PLAN COMMISSION MEETING

Administrative Staff Report

Marshfield Clinic Health System

Site Plan & Architectural Review

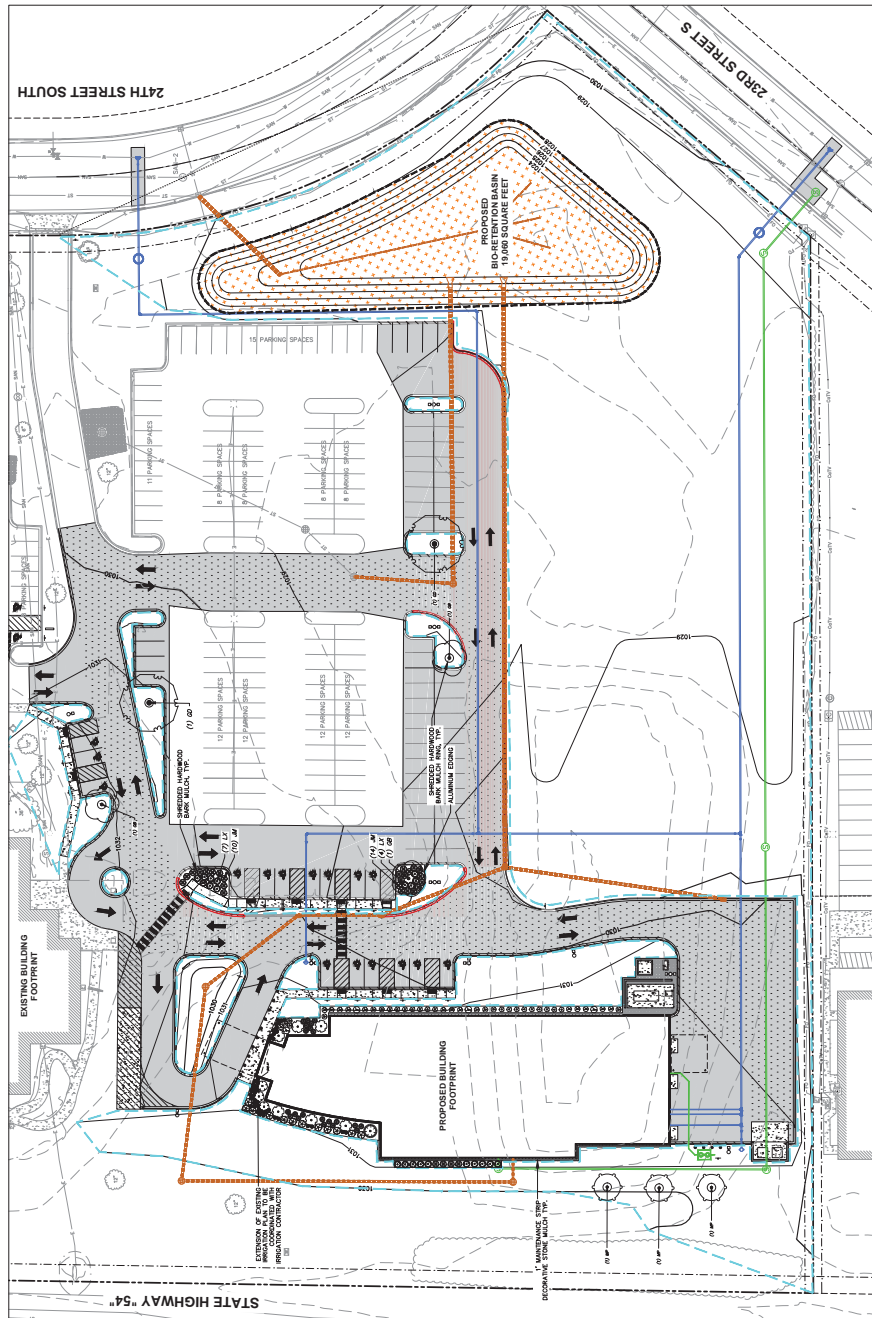
Findings: The applicant is not showing adequate street frontage plantings along STH 54, Peach Street, 24th Street South, or 23rd Street South. Street frontage along STH 54 is 620 feet, which would require 372 points planting that include mainly tall and medium deciduous trees. Peach Street would require 312 points, 24th St. S. would require 301 points, and 23rd St. S. would require 124 points. Additionally, foundation plantings as shown are not adequate, as they do not meet the points minimum, but also should continue along the length of the west building facade. This elevation is highly visible from STH 54 and this elevation would benefit from being broken up with a variety of plantings.

Parking lot landscaping as shown is minimal. In addition, the entire heavily forested southeast corner of the lot is proposed to be cleared to construct the proposed bioretention basin. Trees within the setback would be required to be retained consistent with tree preservation zone requirements as outlined in the WBCPC. Staff would suggest that some of the required perimeter parking lot landscaping be integrated here, to surround the bioretention area. Any existing vegetation can also be used to meet the applicable planting requirements. The applicant shall submit an updated landscape plan as a condition of approval, to be reviewed and approved by the Community Development Department.

**OVERALL &
EXTERIOR
ELEVATIONS**

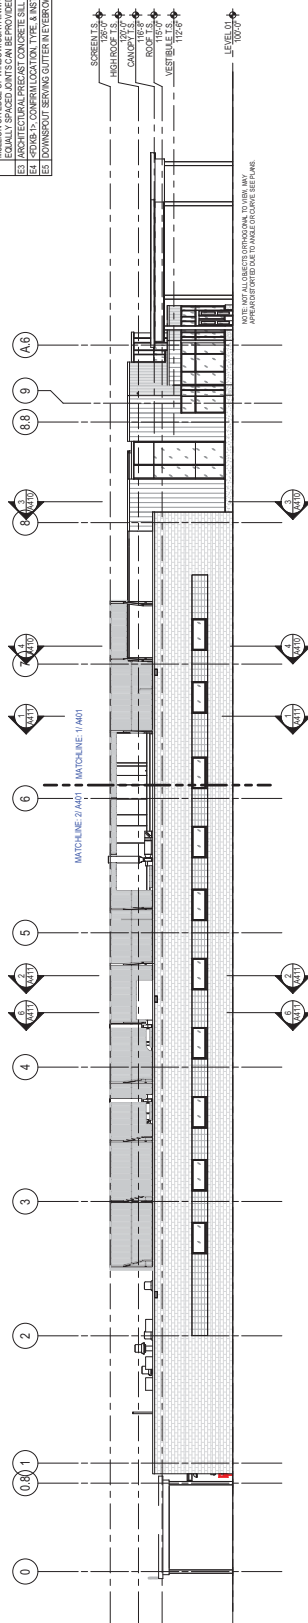
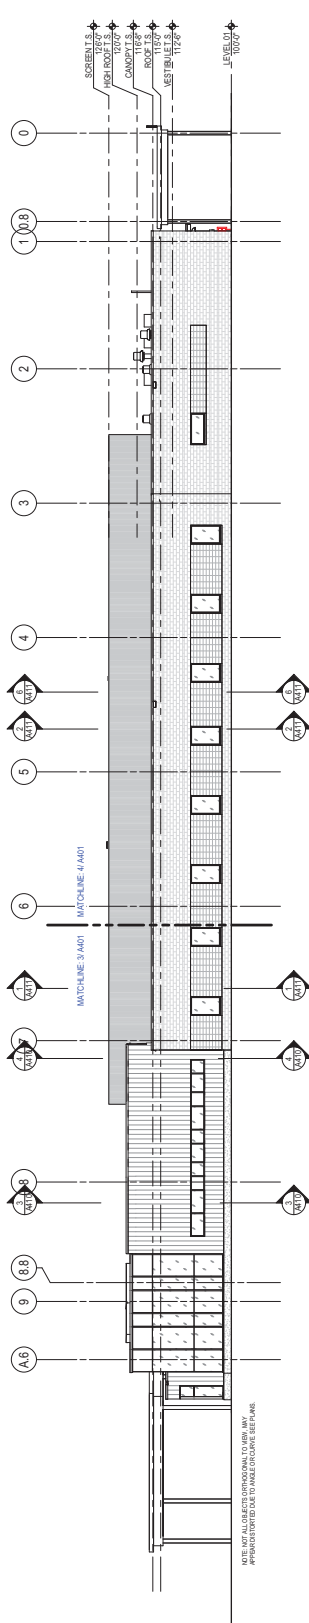
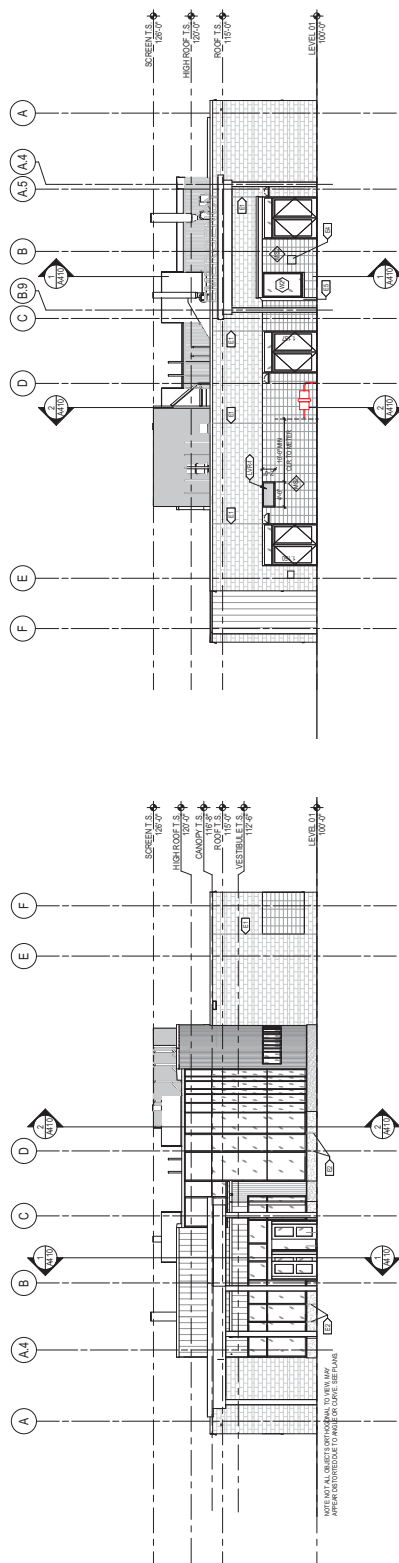
Analysis: Renderings have been submitted; however, staff has requested more detail about finished materials. The north elevation includes a variety of architectural elements. The east and west elevations are somewhat repetitive and would be enhanced by more diversification and multidimensional variation. Refuse and utilities are proposed to be screened by split-faced concrete block walls to match the principal structure.

Findings: From an architectural standpoint, the proposed east and west elevations are somewhat repetitive. Particularly the west elevation, which is highly visible from STH 54, should include elements that provide visual interest. This can be done through vertical or horizontal wall offsets or other multidimensional design features. This along with the additional landscaping will create a more attractive design along STH 54.

Architecture, particularly the west elevation is highly visible from STH 54. Therefore, care should be placed upon adding visual interest to that side of the building. Additionally, there are opportunities for enhanced landscaping along this street frontage and around the building. The proposed bioretention basin will serve to attenuate and treat stormwater runoff. However, it is important to note that presently, there are a high concentration of trees in this area. To mitigate the impact of this tree removal, staff is suggesting increased plantings around the parking lot perimeter and integration of landscaping into the bioretention basin perimeter as well.
